Changes to proposed District Map Amendment G-956

A revised version of DMA G-956, dated July 11, 2014, has been posted on the Planning Department website for review. It contains all of the proposed and approved changes that have occurred since May 2, 2013. The following document illustrates all of the changes to DMA G-956 since April 2014.

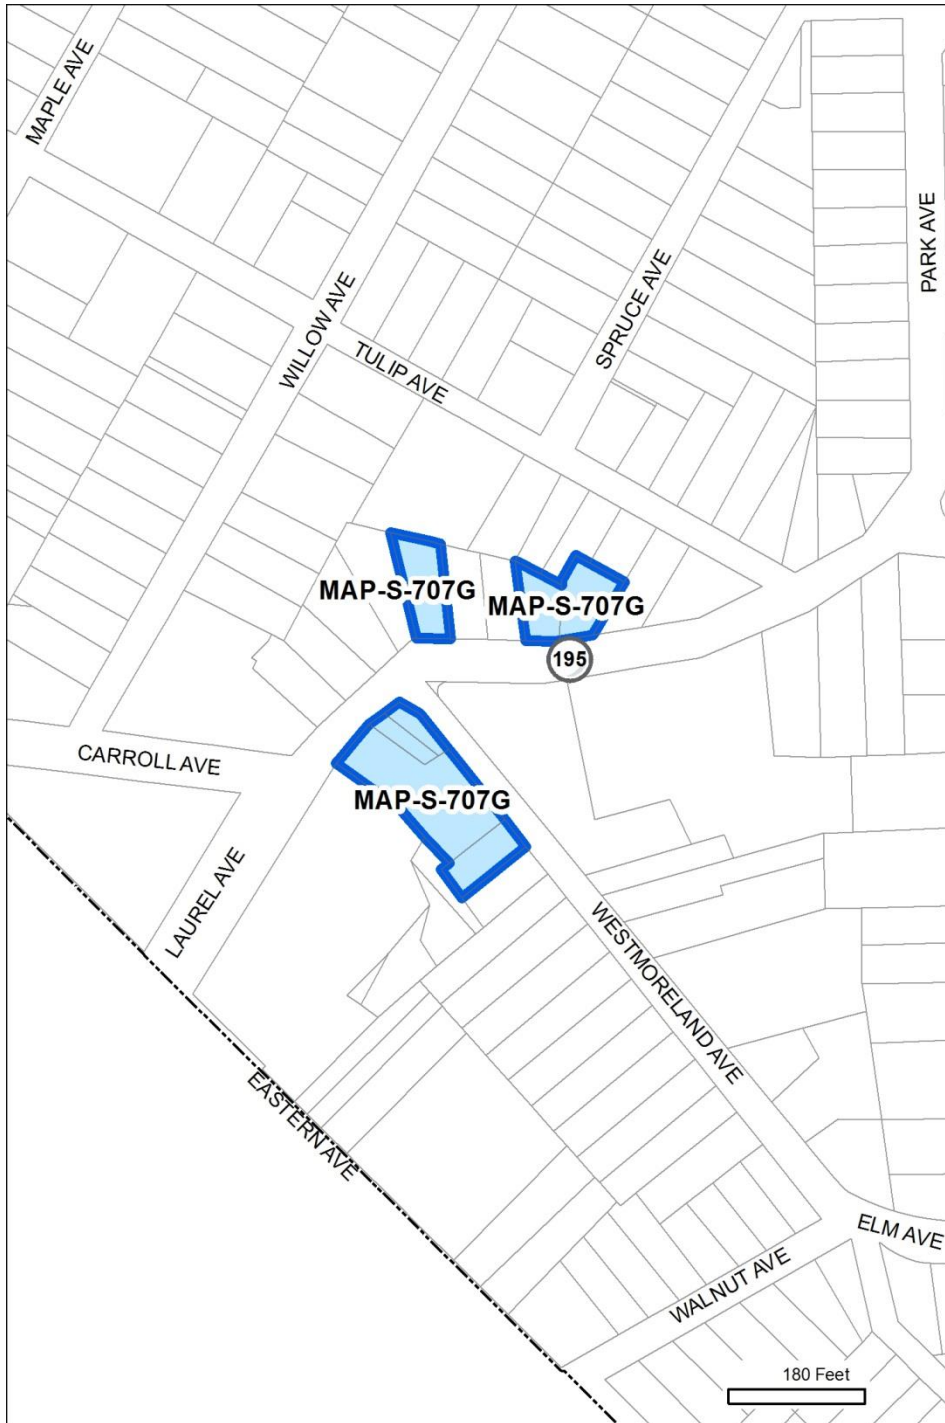
Unique ID: MAP-S-707F		staff change
Master Plan ID: TAKOM-02W		
Master Plan:	Takoma Park	
Location:	Old Takoma	
Existing Zone:	C-1	
Proposed Conv: (6/2)	CRT-0.5 C-0.5 R-0.25 H-50	
Prop. Revised Conv:	NR-0.75 H-50	
Category:	Recommended Change	
Modifications	Zone Group:	Changed to NR
	Overall FAR:	Increased to 0.75
	Comm'l FAR:	-
	Resid'l FAR:	-
	Height:	No change
Reason for change:		
<i>This property is zoned C-1 and are in a Master Plan designated historic district.</i>		
<i>Staff recommended changing the "standard" conversion for C-1 in a historic district to NR-0.75 H-45.</i>		
<i>However, the Takoma Park / East Silver Spring Commercial Revitalization Overlay allows height to 50'.</i>		
<i>Therefore, the revised conversion should be to NR-0.75 H-50.</i>

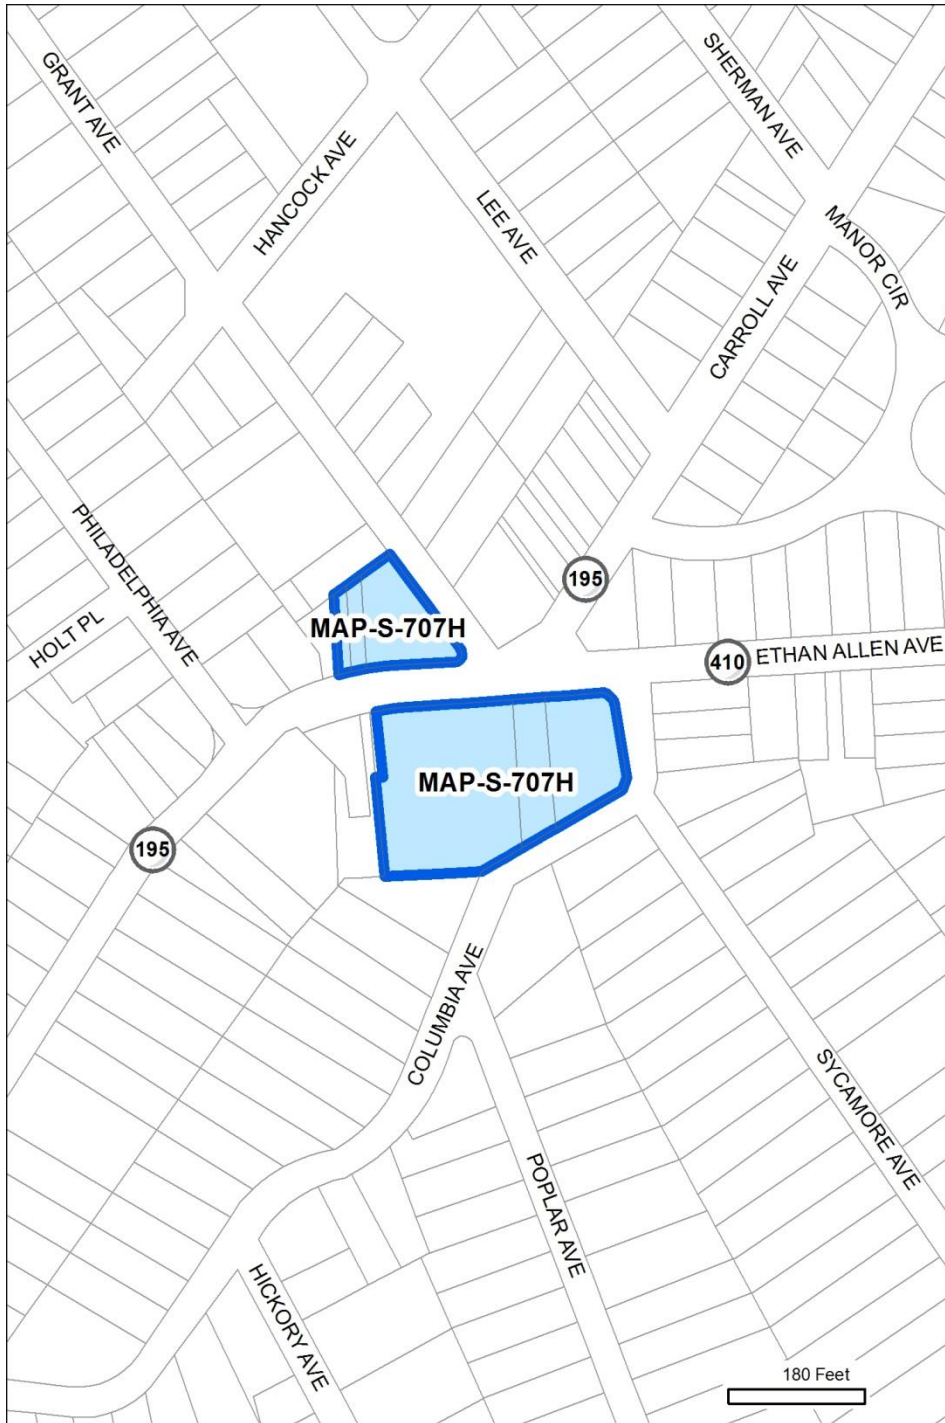
Unique ID: MAP-S-707G		staff change
Master Plan ID: TAKOM-04		
Master Plan:	Takoma Park	
Location:	Old Takoma	
Existing Zone:	C-1	
Proposed Conv: (6/2)	CRT-1.0 C-0.75 R-0.5 H-50	
Prop. Revised Conv:	NR-0.75 H-50	
Category:	Recommended Change	
Modifications	Zone Group:	Changed to NR
	Overall FAR:	Reduced to 0.75
	Comm'l FAR:	-
	Resid'l FAR:	-
	Height:	No change
Reason for change:		
<p><i>This property is zoned C-1 and are in a Master Plan designated historic district.</i></p> <p><i>Staff recommended changing the "standard" conversion for C-1 in a historic district to NR-0.75 H-45.</i></p> <p><i>However, the Takoma Park / East Silver Spring Commercial Revitalization Overlay allows height to 50'.</i></p> <p><i>Therefore, the revised conversion should be to NR-0.75 H-50.</i></p>

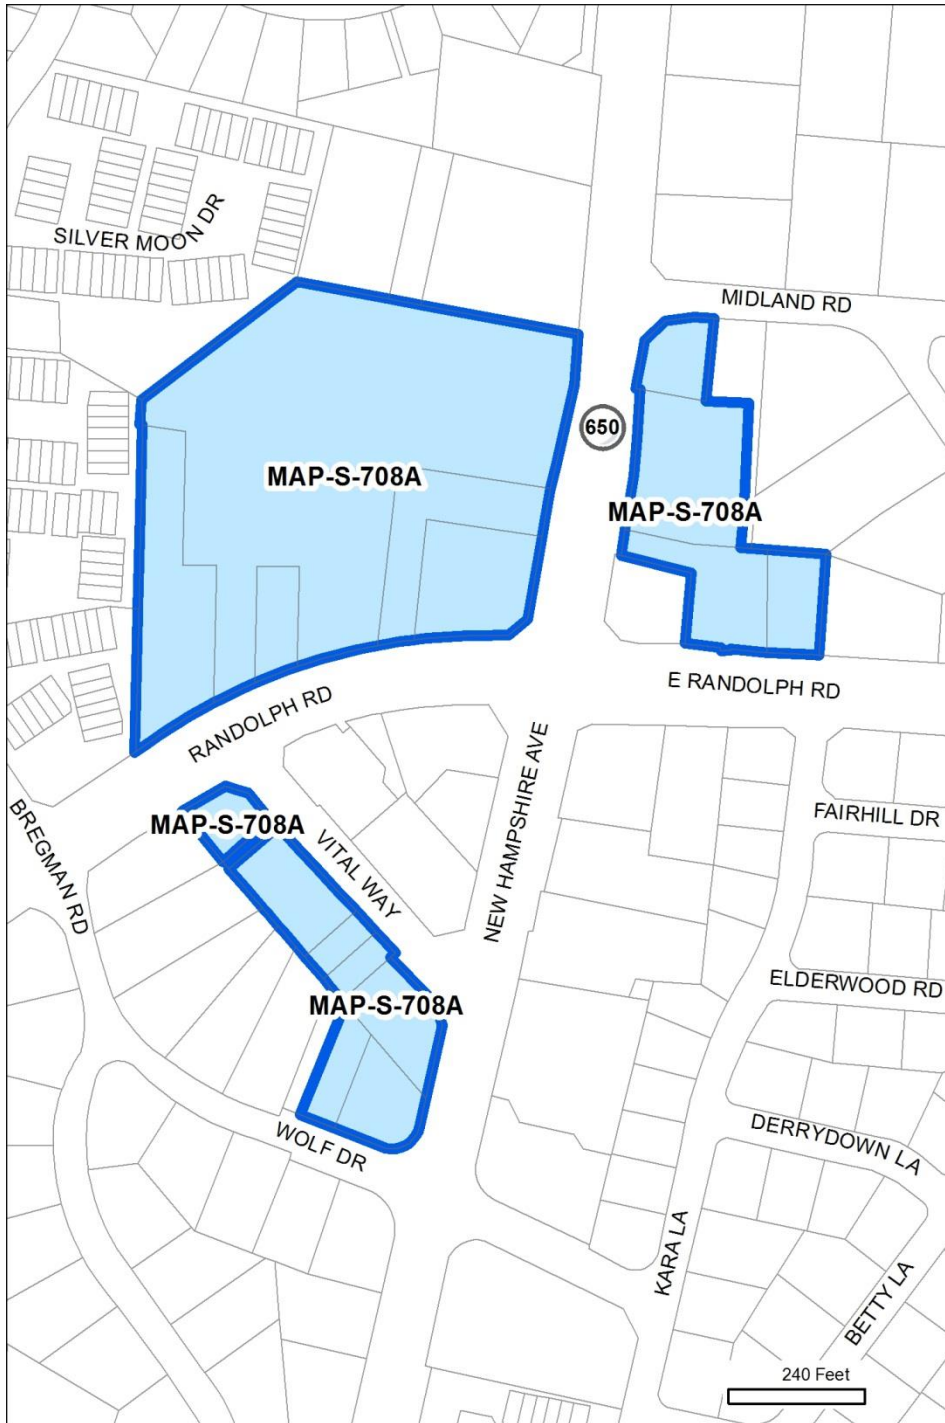
Unique ID: MAP-S-707J		staff change
Master Plan ID: TAKOM-02E		
Master Plan:	Takoma Park	
Location:	Old Takoma	
Existing Zone:	C-1	
Proposed Conv: (6/2)	CRT-0.5 C-0.5 R-0.25 H-50	
Prop. Revised Conv:	NR-0.75 H-50	
Category:	Recommended Change	
Modifications	Zone Group:	Changed to NR
	Overall FAR:	Increased to 0.75
	Comm'l FAR:	-
	Resid'l FAR:	-
	Height:	No change
Reason for change:		
<p><i>This property is zoned C-1 and are in a Master Plan designated historic district.</i></p> <p><i>Staff recommended changing the "standard" conversion for C-1 in a historic district to NR-0.75 H-45.</i></p> <p><i>However, the Takoma Park / East Silver Spring Commercial Revitalization Overlay allows height to 50'.</i></p> <p><i>Therefore, the revised conversion should be to NR-0.75 H-50.</i></p>
